IEEE P802.11
Wireless LANs

LB133: Normative Text Update for Annex Q**Date:** 2008-SEP-11**Author(s):**

This document contains normative text updates for Annex Q to TGv draft. Updates include corrections noted since last meeting, expanded detail in several Report Tables and conformance group definitions for new MIB variables.

This document shows redlines from TGv draft 3.02.

Annex Q

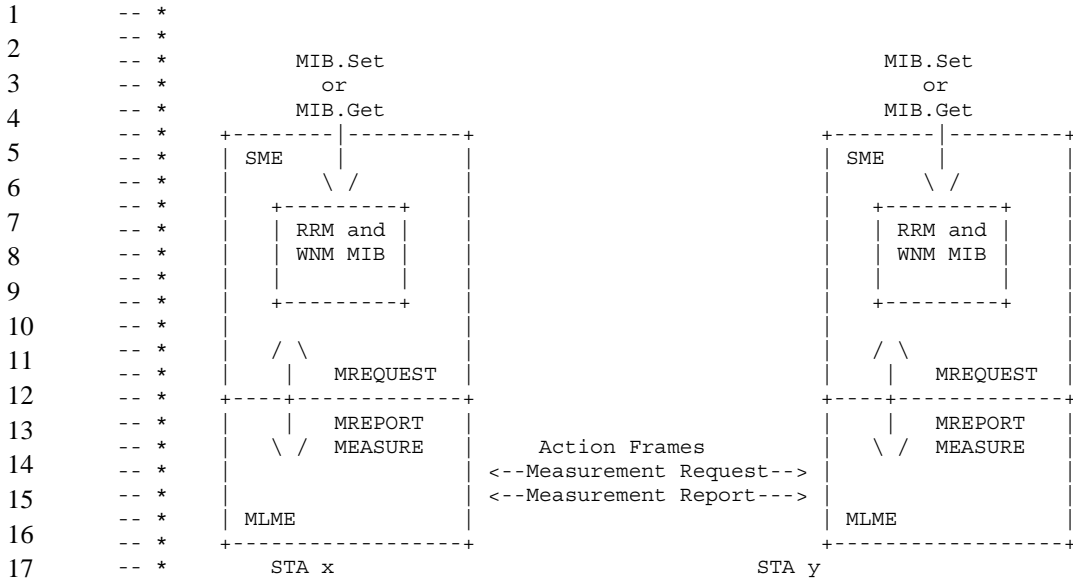
Rename and modify Annex Q as shown:
